re **Planning Proposal for the “Sydney Martin Place Station Precinct” –
PP_2017_SYDNEY_007_00
50 Martin Place, 9-19 Elizabeth Street, 8-12 Castlereagh Street, 5 & 7 Elizabeth
Street and 55 Hunter Street (“the north site”)
39 Martin Place (“the south site”)**

Analysis of Design Intent and Potential
Impacts of a Planning Proposal
for the Sydney Metro Martin
Place Station Precinct

Design Advisory Panel - Martin Place Planning Proposal

Public Plaza - Planning Proposal envelope

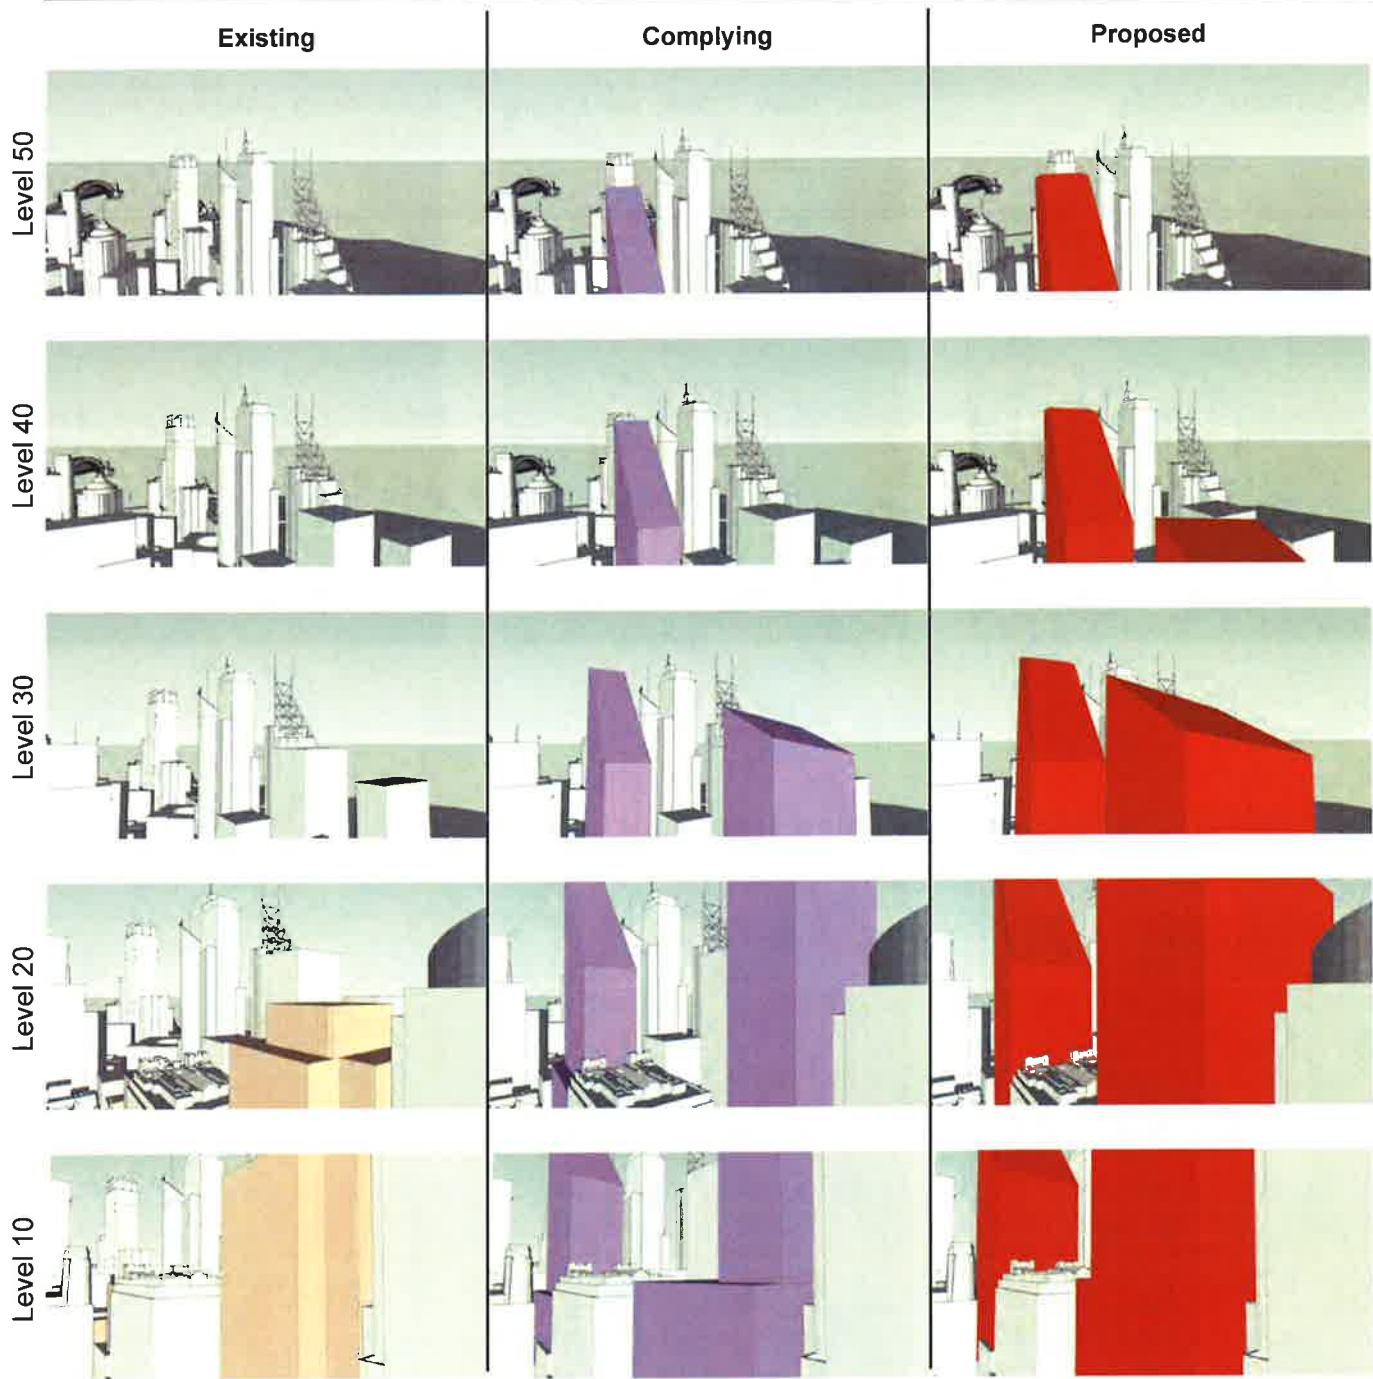
The report advances a planning opinion that the design of the MLC Centre warrants an increase, beyond the Sydney LEP and DCP, of bulk and scale of the tower portion of the South Site. The consequences of this planning opinion are not justified architecturally.

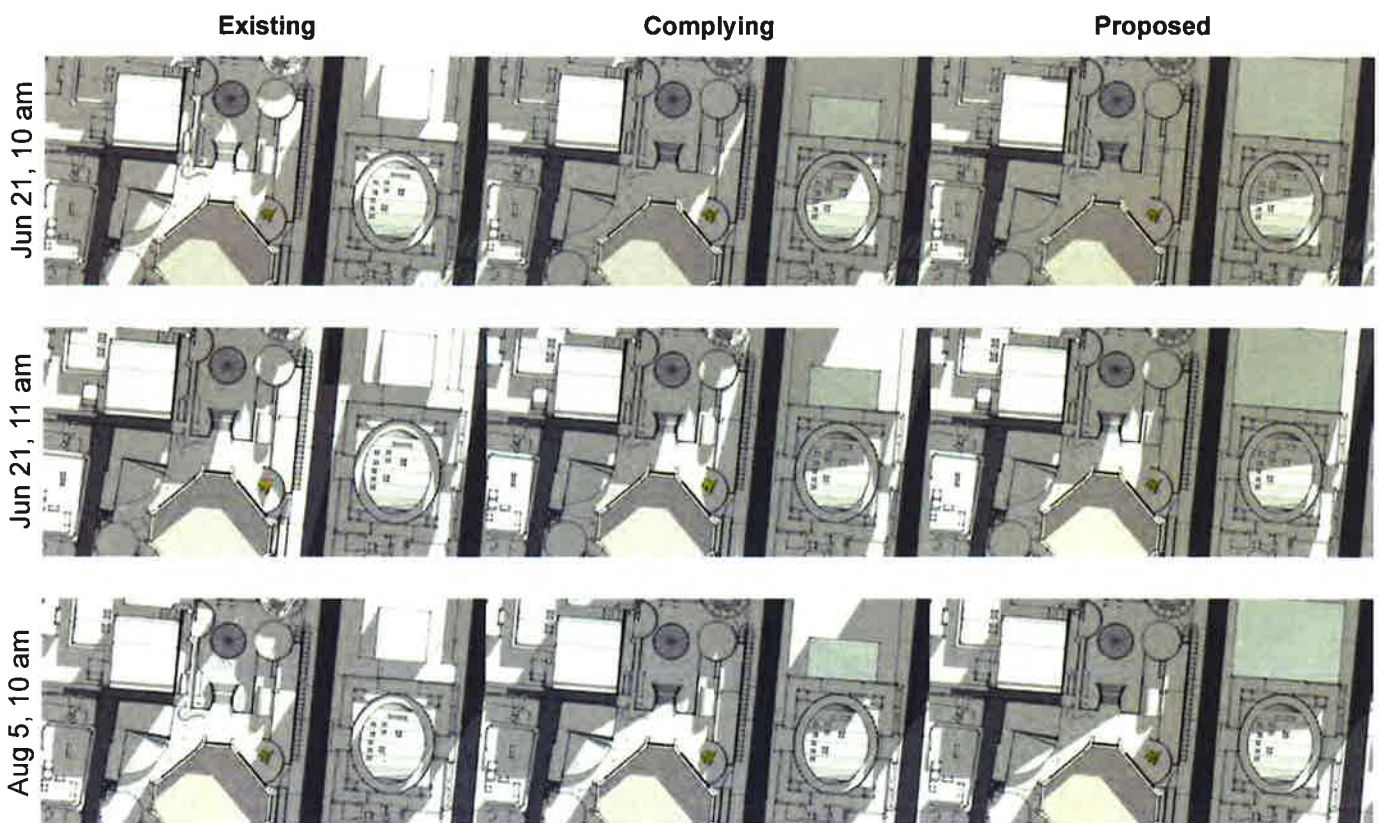
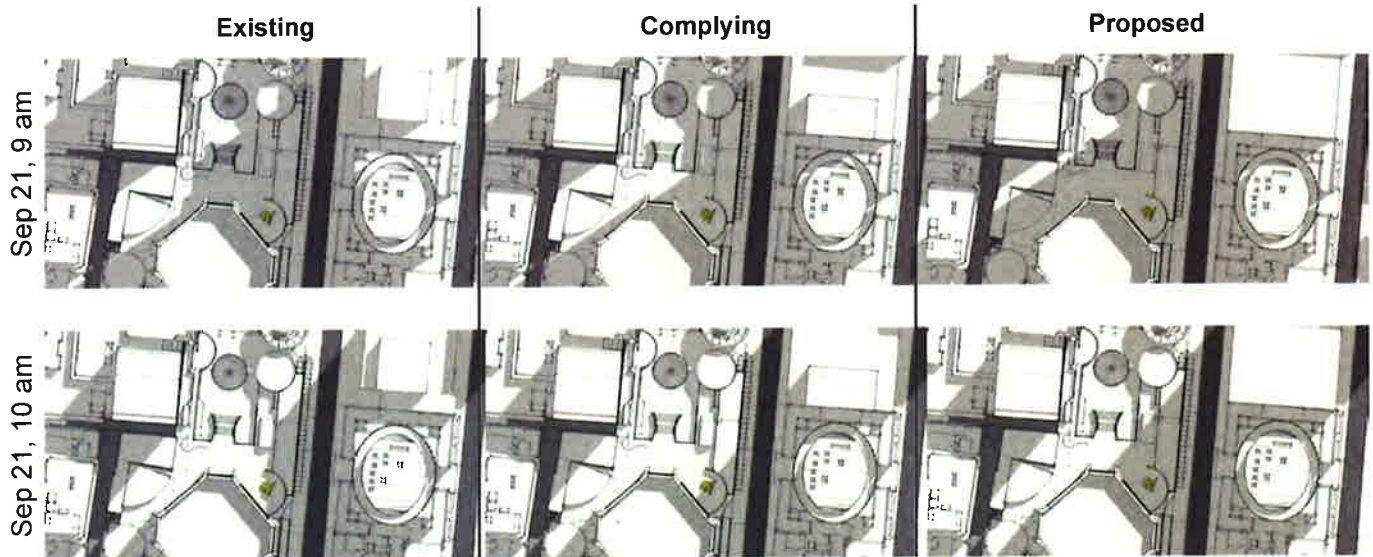
Significant for the MLC Centre is the increased overshading of the public plaza by the North Site Planning Proposal envelope when compared with the existing conditions during the winter months of April to August.

Also significant for the MLC Centre is the increased overshading of the public plaza by the South Site Planning Proposal envelope when compared with the existing conditions during the months of August to December.

Both of the Planning Proposal's over-station tower envelopes reduce the amount of sunlight received by the MLC Centre public plaza in the morning, throughout the year.

The Planning Proposal should include Sun-Eye View analysis of overshadowing to allow a complete understanding of the impacts of the proposed built form.

Impact on views and outlook from MLC Tower Level 50

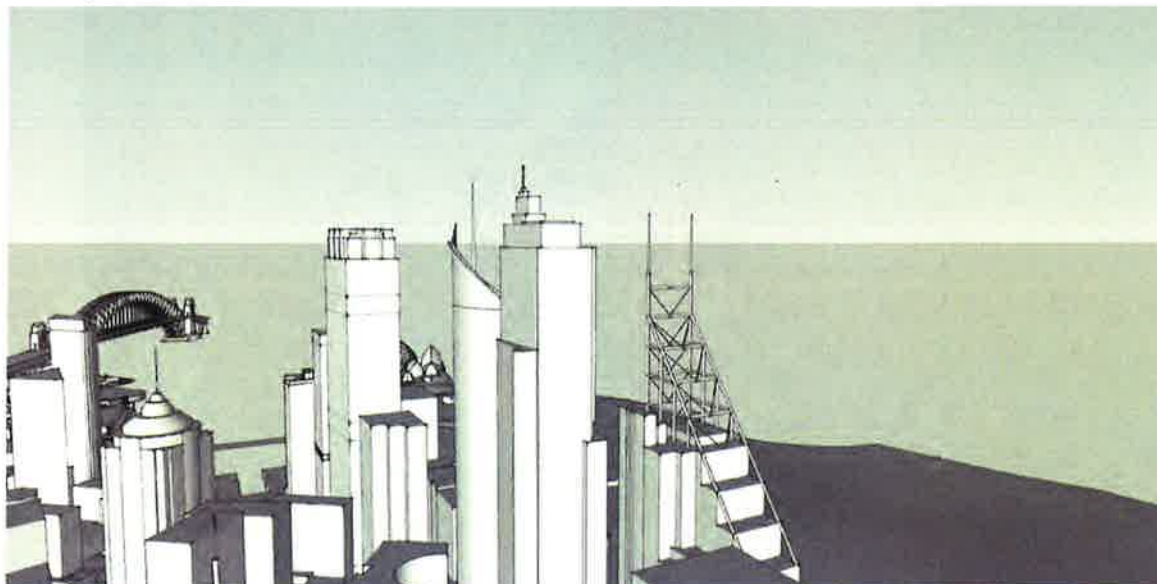
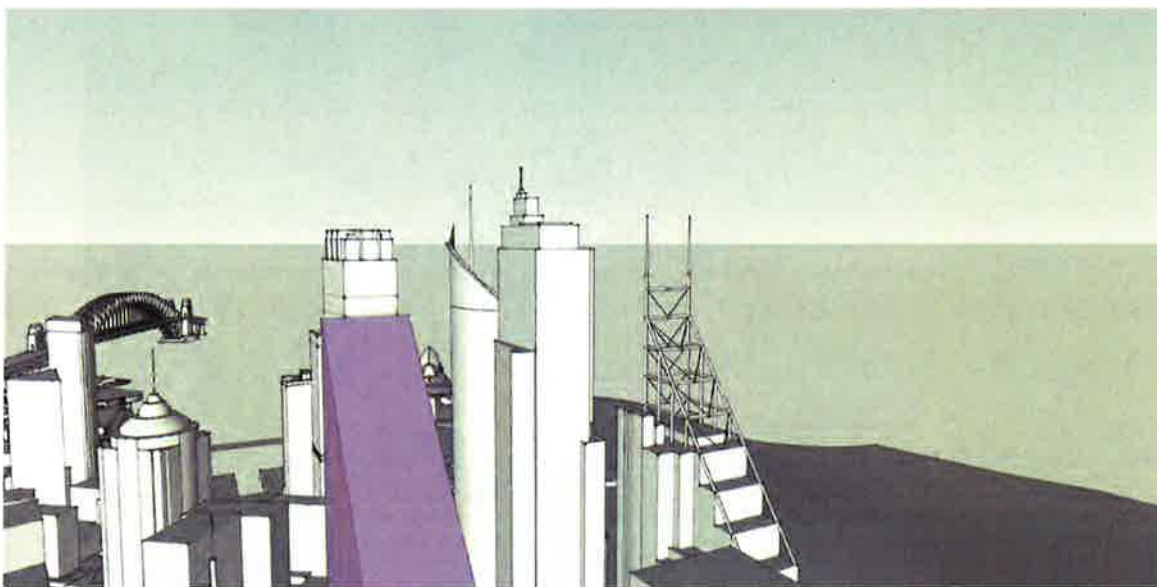
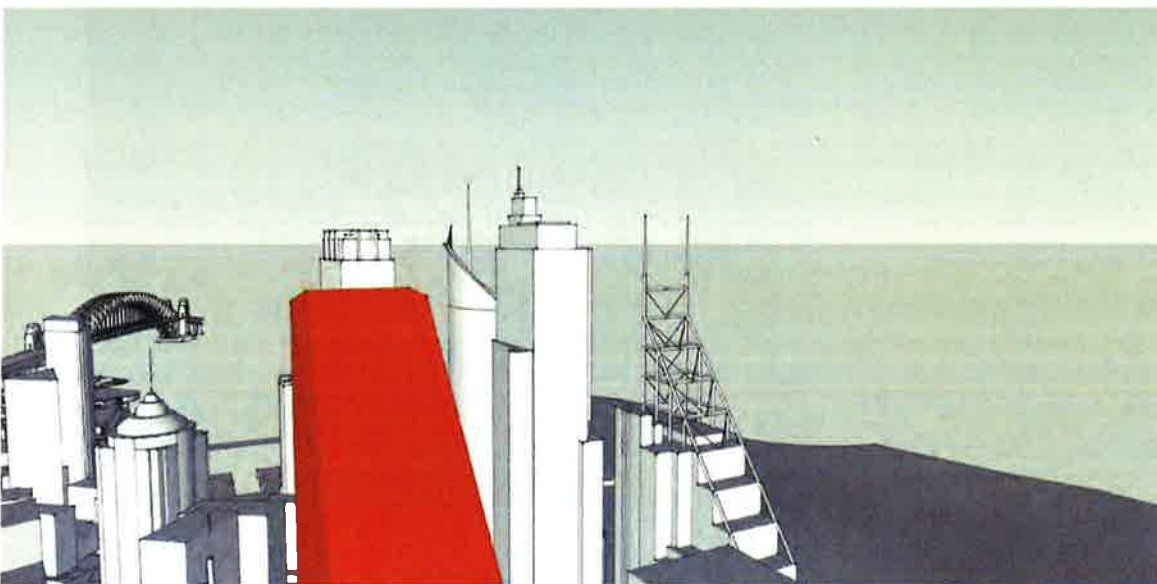
Existing outlook and sky views from the MLC Centre tower are significantly impacted by the Planning Proposal building envelope for the South Site when compared to the building envelope allowable under the Sydney Local Environment Plan (LEP 2012) and the Sydney Development Control Plan (DCP 2012), and the existing situation.

Shadow study on the 21st June 10 am

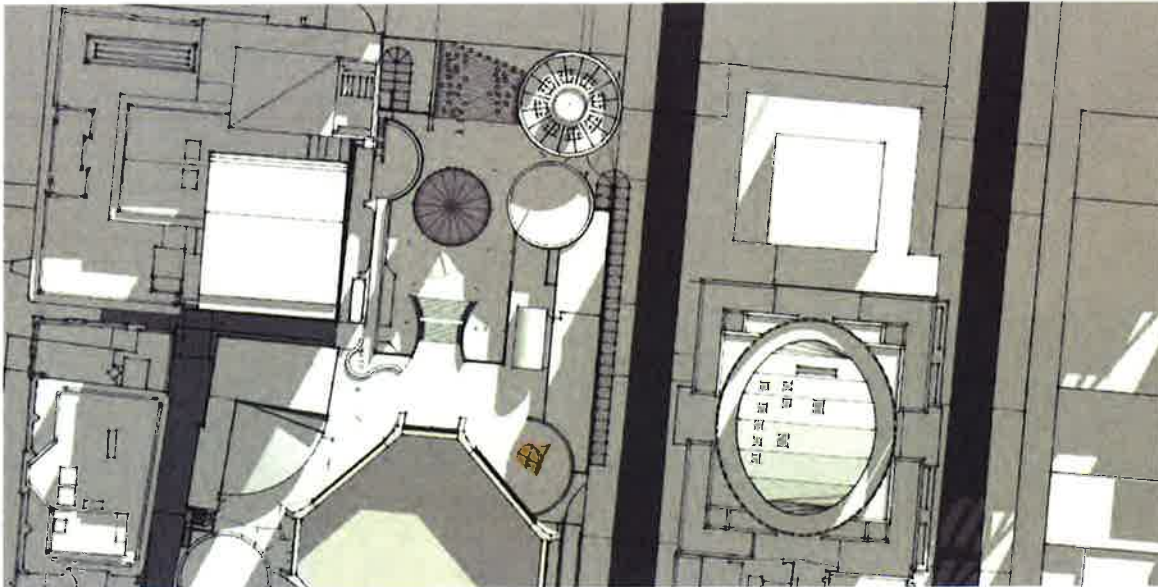
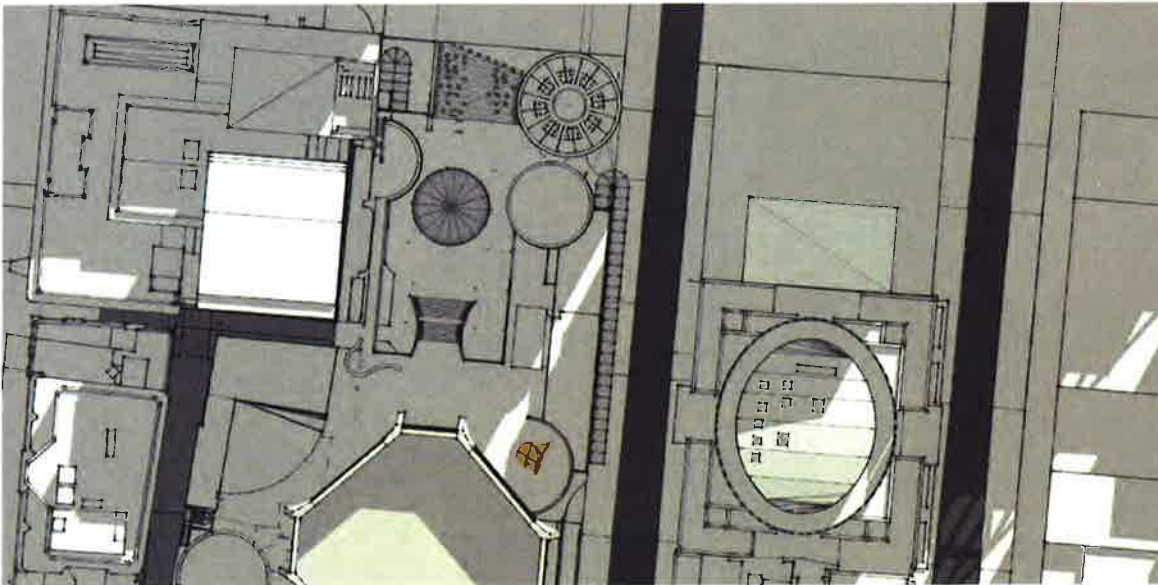
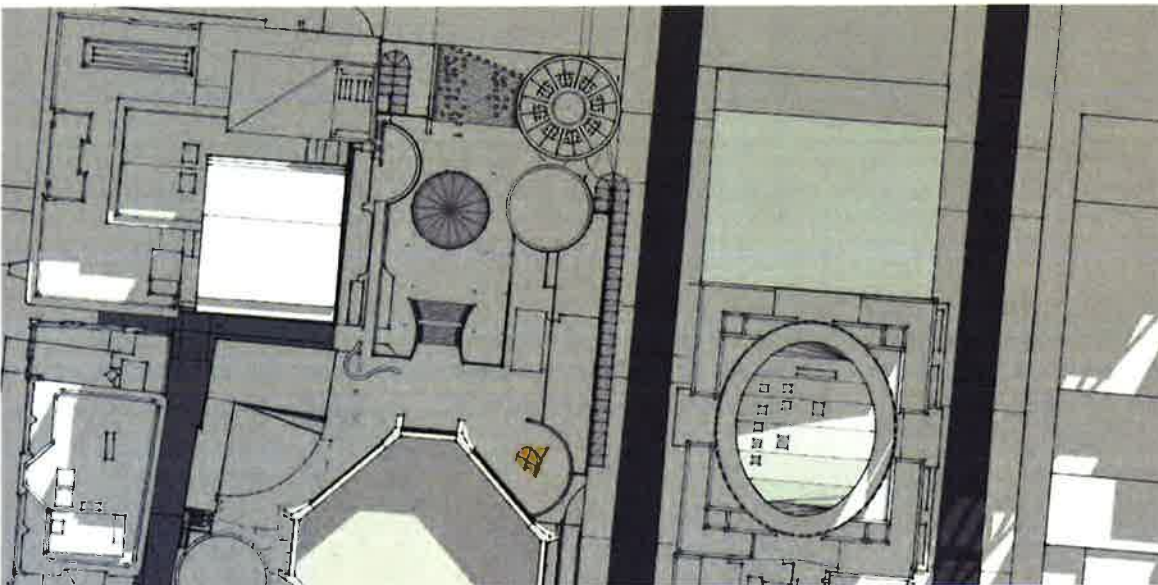
Should the Planning Proposal be approved, the MLC Centre will suffer additional over-shading of the public plaza in the morning, throughout the year, when compared to the existing conditions and the Sydney LEP2012 and DCP2012 compliant envelope.
